ADDENDUM NO. 2

for
**STEM LAB ALTERATIONS AND RENOVATIONS AT
CLEARVIEW REGIONAL MIDDLE SCHOOL**
located at 595 Jefferson Road, Mullica Hill, NJ 08062

Issued: November 1, 2023

FVHD PROJECT #5162C

1 STEM LAB - LIGHTING REMOVAL WORK
SCALE: 1/4" = 1'-0"

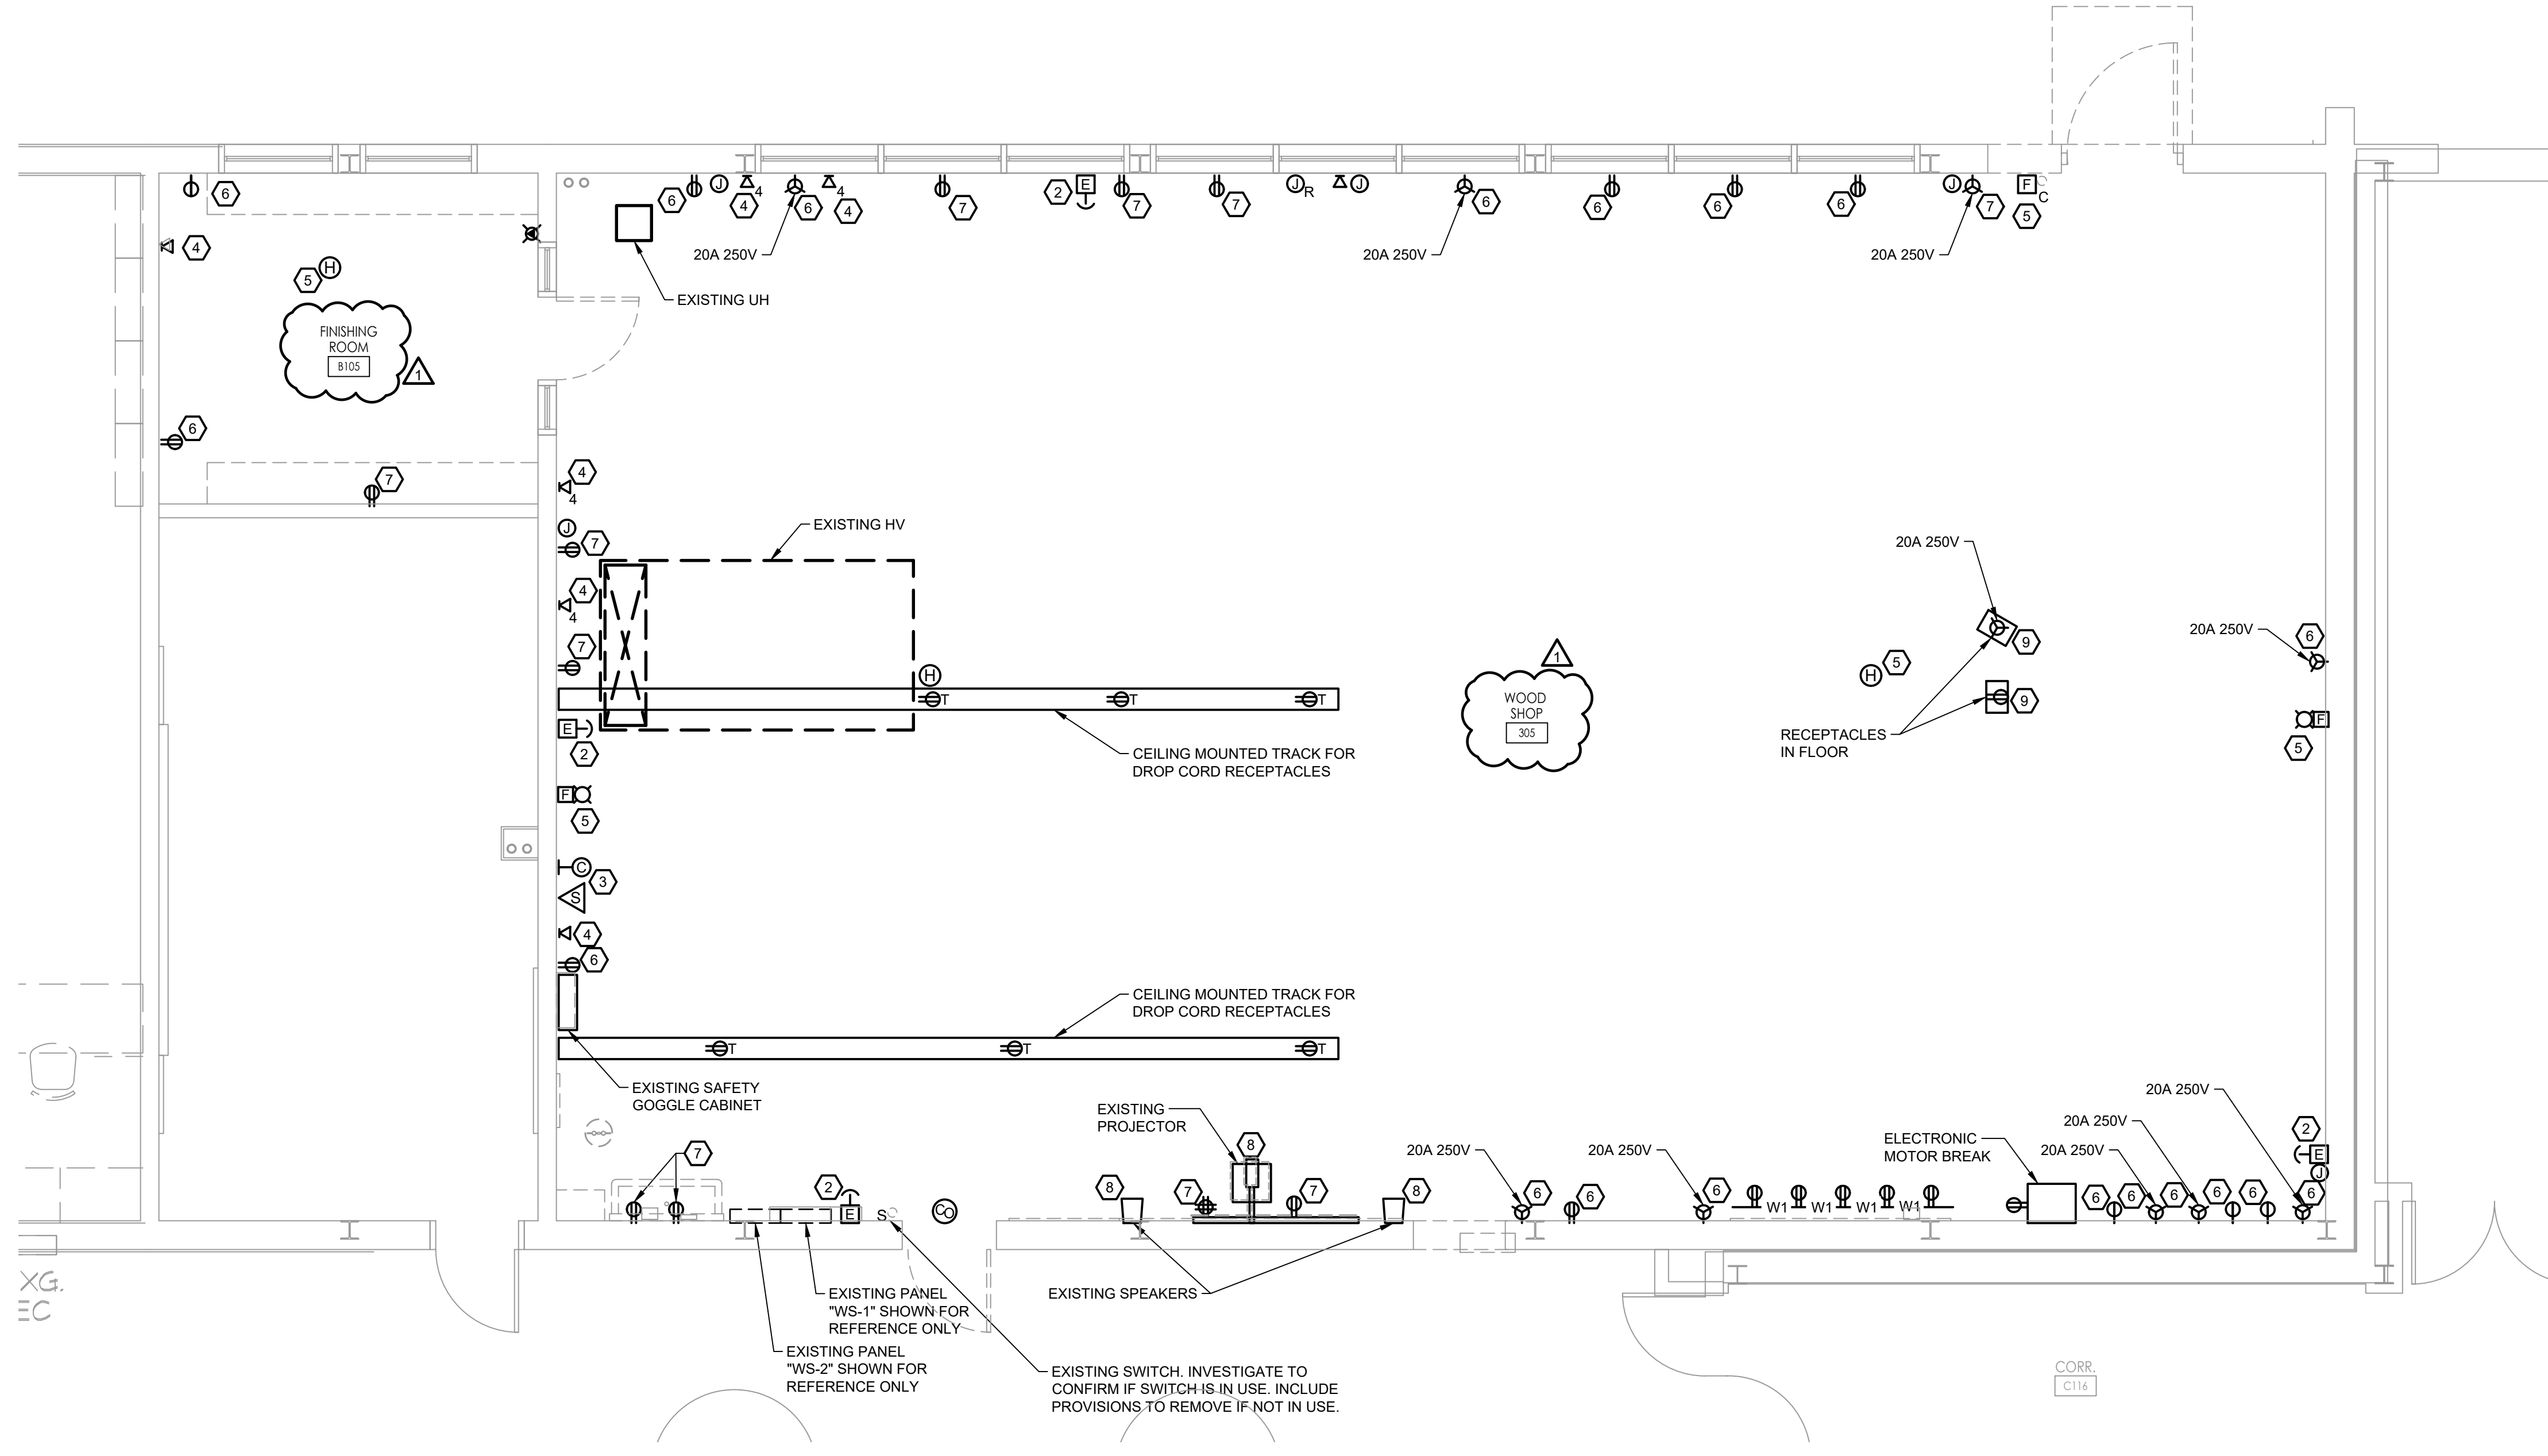
5.3.2. Drawing E101:

5.3.2.1. Change removal note number 3 to read as follows: Remove, clean and store existing clock, speaker, and cover from the back box for reinstallation as shown on 2/E201. Protect the wire connections in the back box from paint and dirt. Back box is to remain in place.
